August 28, 2002

**Re: GE-Pittsfield/Housatonic River Site  
Building 71 On-Plant Consolidation Area (GECD200)  
Design Modifications**

GENERAL ELECTRIC COMPANY • PITTSFIELD, MASSACHUSETTS  
2002 OPCA CONSTRUCTION AND CONSOLIDATION ACTIVITIES  
**BUILDING 71 OPCA SUBGRADE PLAN**

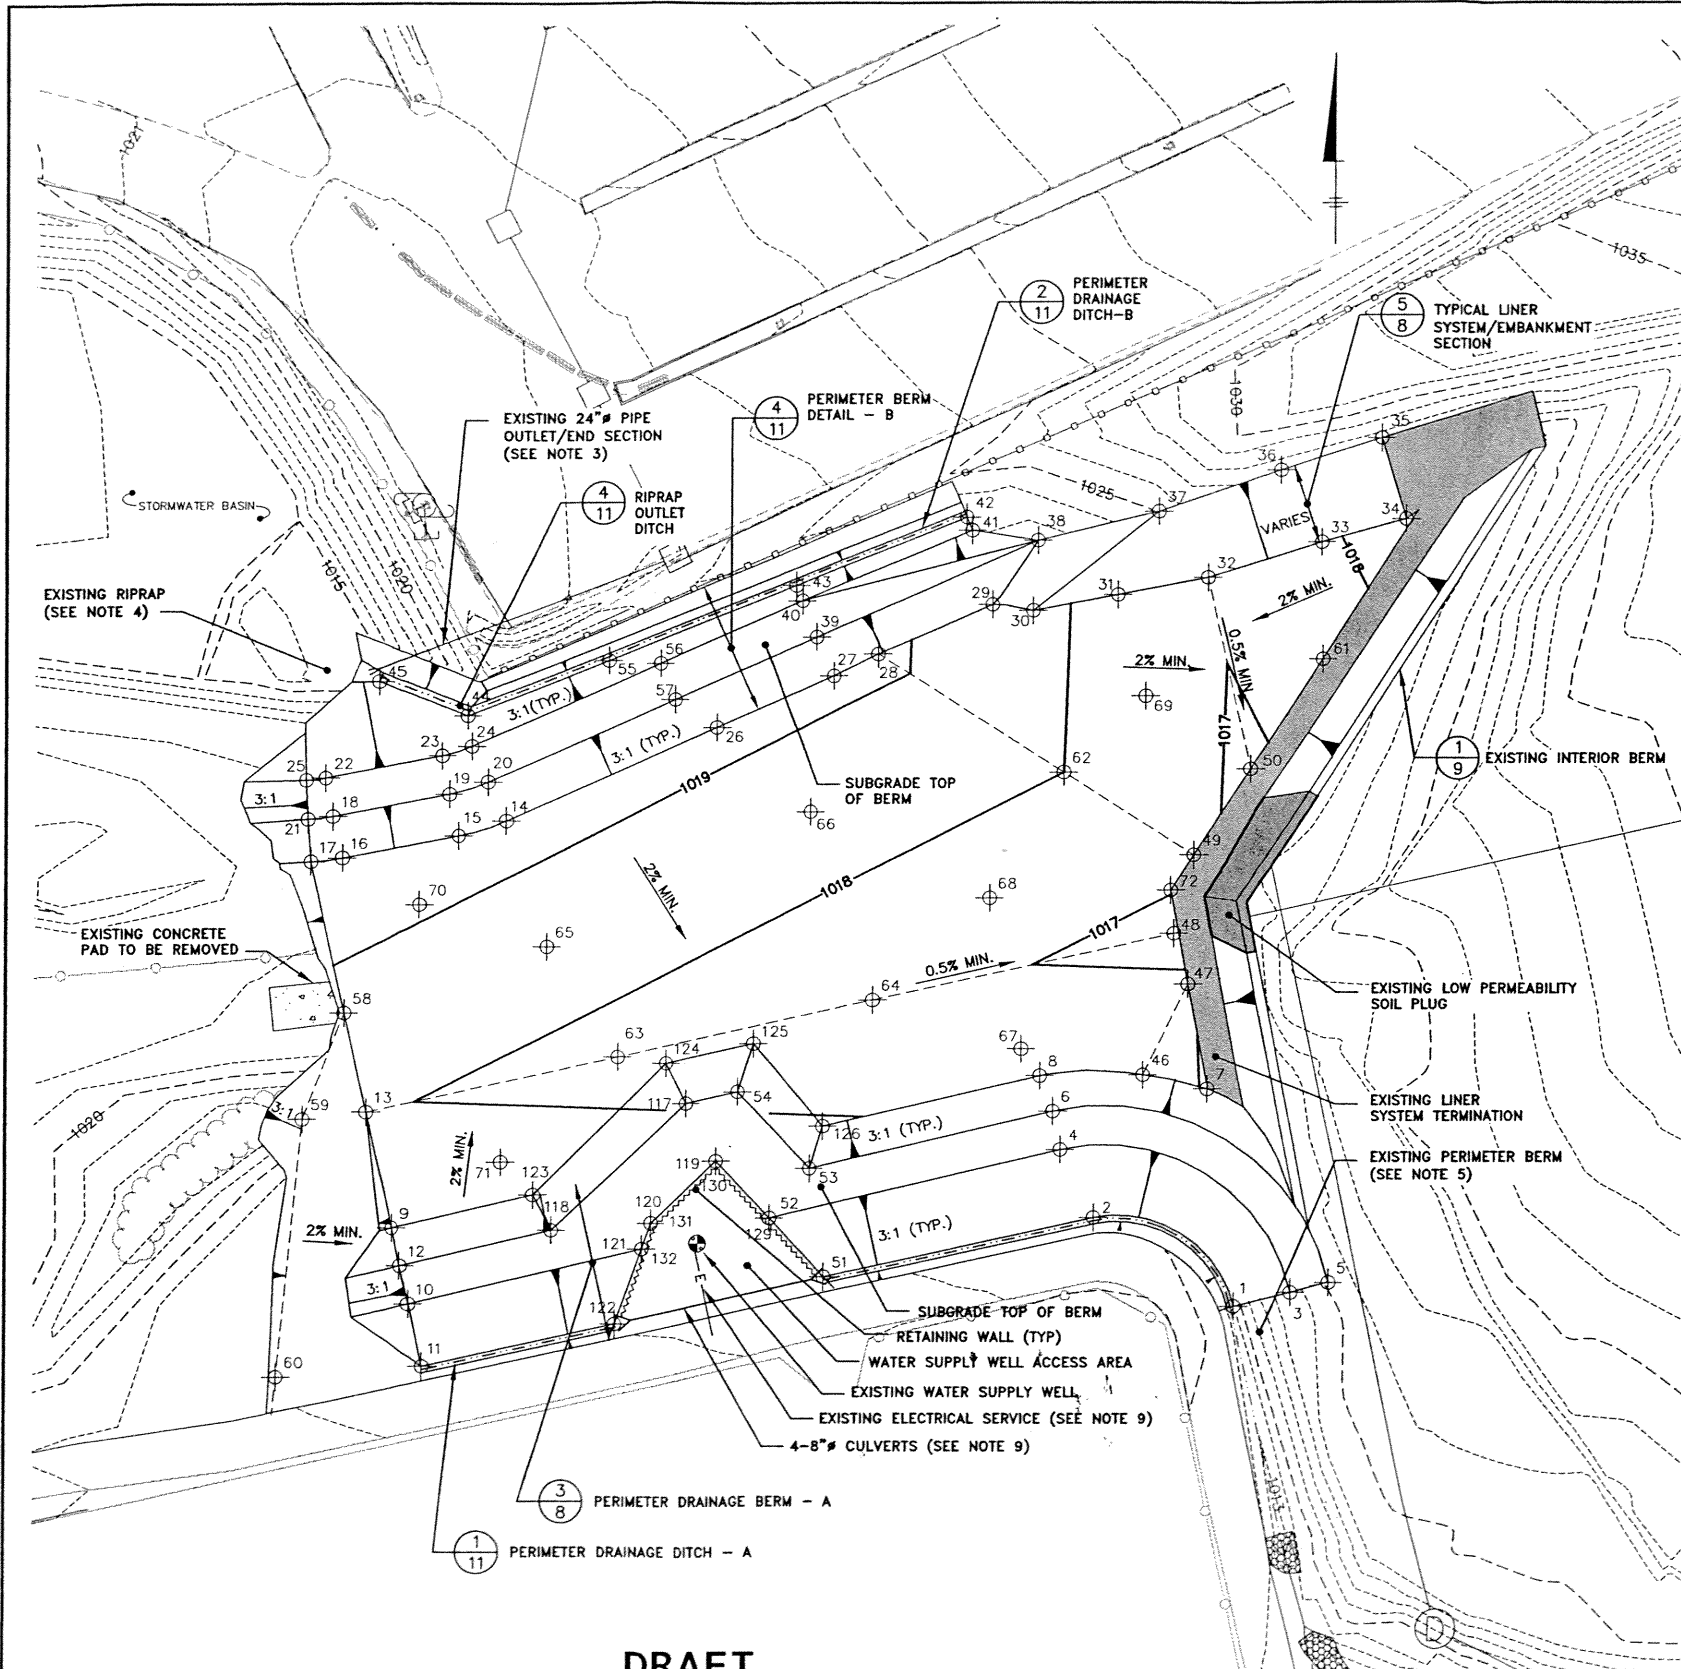
The attached design drawing and figures provide the location and geometry of the two retaining walls, as well as the new equipment access area around the supply well and the modified berm and anchor trench configuration behind the retaining wall. Drawing Z-1 (formerly Drawing 5 from Attachment 1 to the March 27, 2002 letter) provides the proposed plan view of the area surrounding the well and the proposed retaining wall, and Figures 1 and 2 provide the cross-section and profile views of the gabion and Keystone Block walls, respectively.

As indicated on the drawing and figures, the modification to the anchor trench design entails moving the system approximately 10 to 15 feet behind the selected wall system. The actual anchor trench configuration will be identical to the anchor trench installed in other areas along the perimeter of the OPCA (i.e., only its location will change). As indicated above, the retaining wall design consists of either a gravity gabion basket wall or a Keystone Block wall (with geogrid reinforcement) to a maximum height of approximately 15 feet (including the subsurface portions). The height of the retaining wall to be constructed this year will approximate the berm elevation, as shown on the attached figures.
